Commonwealth Edison

Subject: Byron Generating Station Units 1 and 2
Braidwood Generating Station Units 1 and 2
FSAR Changes
NRC Docket Nos. 50-454/455 and 50-456/457

ATTACHMENT A

LIST OF REVISED FSAR PAGES

FIGURE 15.3-9

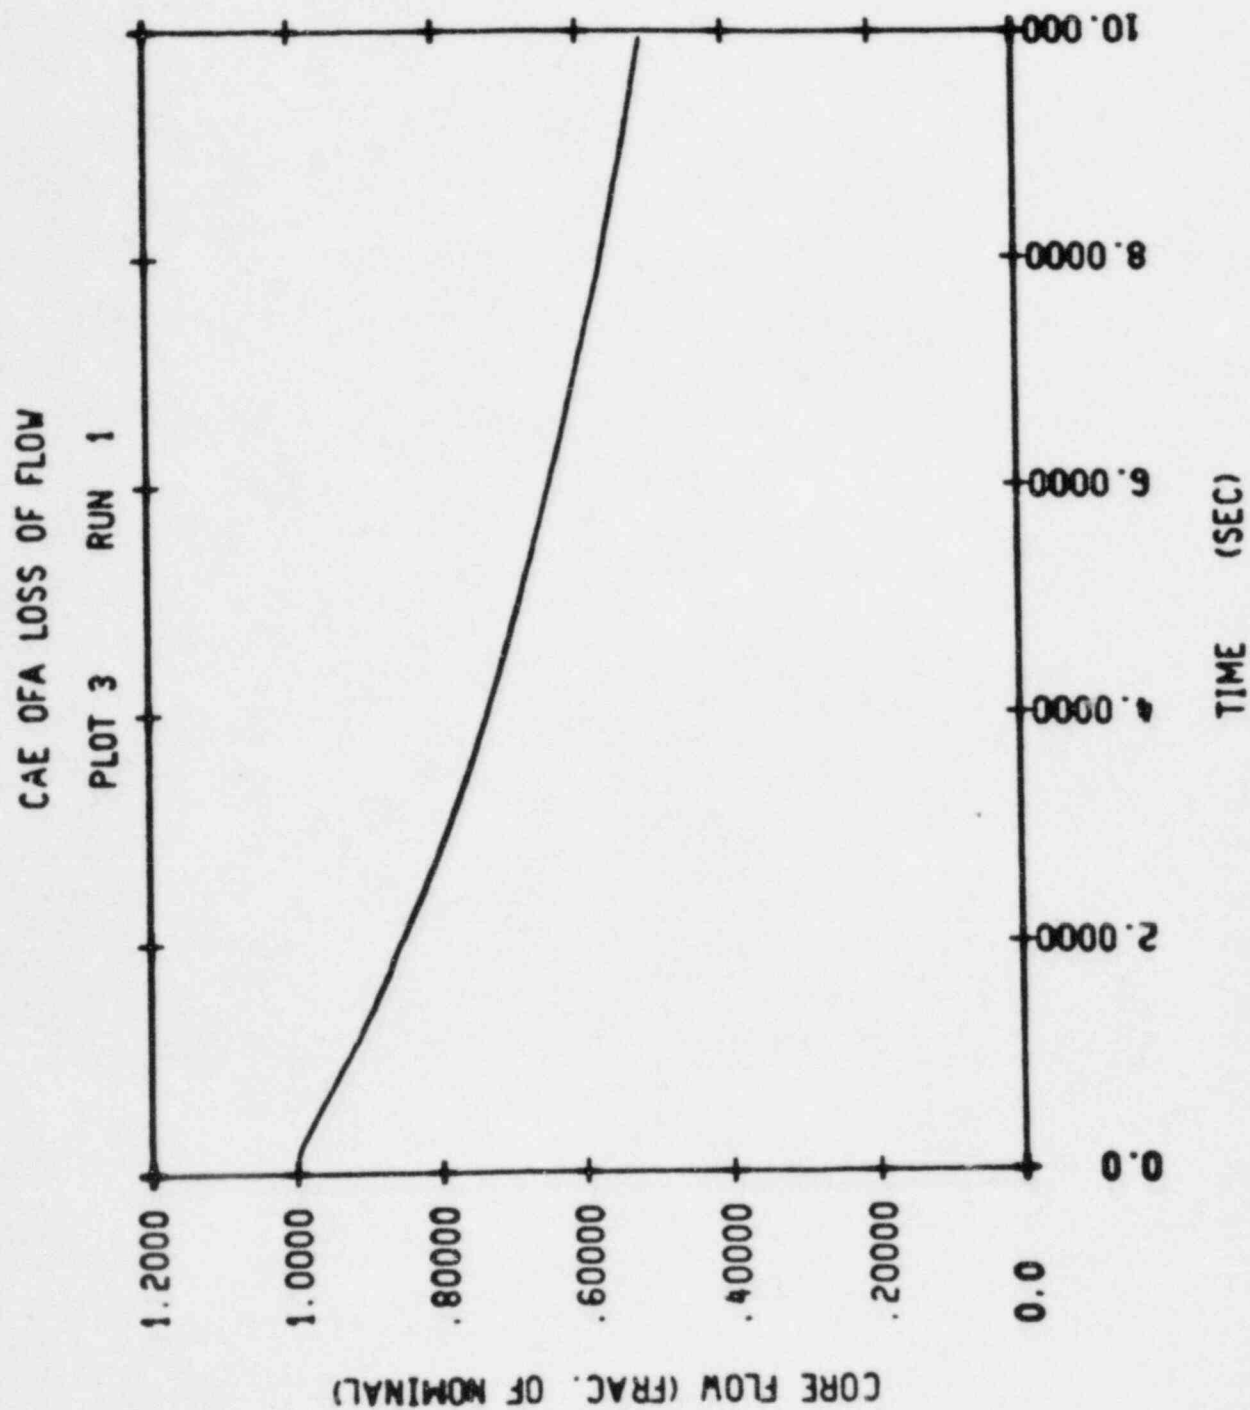
Attachment A to this letter lists the revised FSAR pages which are enclosed. These pages document the Westinghouse reanalysis of the reactor's transient response to a complete loss of forced reactor coolant flow. The reanalysis demonstrates that the minimum DNBR will remain above 1.3, considering the as-built reactor coolant pump performance.

Page 15.3-15, Table 15.3-1	time sequence of events
Figure 15.3-9	flow vs. time
Figure 15.3-10(a)	power vs. time
Figure 15.3-10(b)	pressure vs. time
Figure 15.3-11(a)	heat flux vs. time (aug. channel)
Figure 15.3-11(b)	heat flux vs. time (hot channel)
Figure 15.3-12	DNBR vs. time
